MFN 06-195  
June 23, 2006

**Subject: Responses to Methods RAIs - Interim Methods LTR**

### **Responses to RAIs Related to NEDE-33173P**

**Non-Proprietary Version**

Figure R2.2-1 Sensitivity of Cold Critical Eigenvalue to EPU Operation

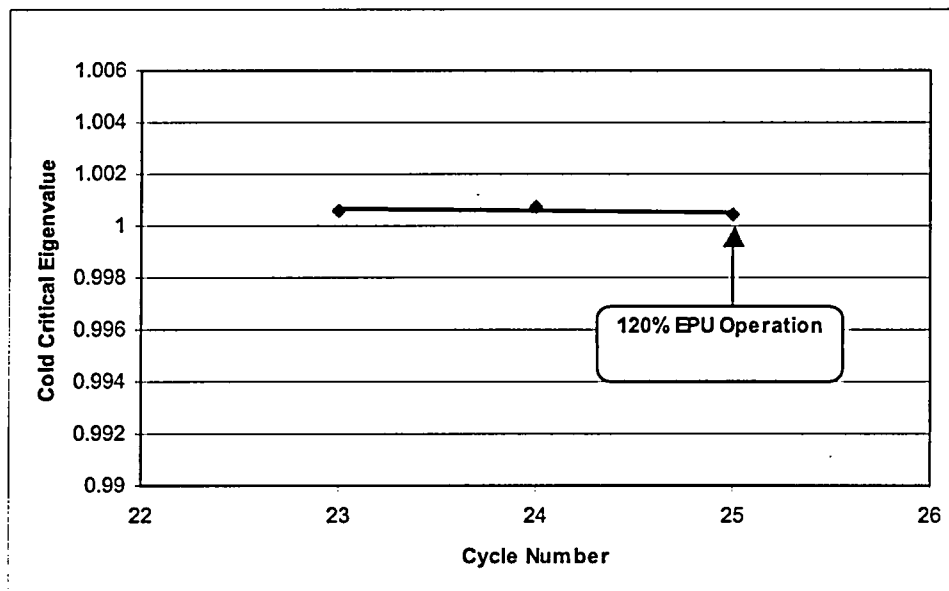
The LTR states that the same SDM Technical Specification value used for non-EPU core designs is adequate for EPU and expanded operating domain conditions. Provide the basis as to why cold SDM is not a strong function of the current operating strategies by comparing cold critical data before and after EPU. Include in the discussion the impact of core designs necessary to achieve EPU and maintain extended cycle lengths (e.g., larger batch fractions, higher bundle enrichments and different core loading patterns).

As a final demonstration of these concepts, the trending of the cold eigenvalues for a BWR/4 through a 120% EPU transition is provided in Figure R2.2-1. The scale of the data is consistent with that given in Figure 2-4 of NEDC-33173P. There is no identifiable aberration with the trend because of EPU.
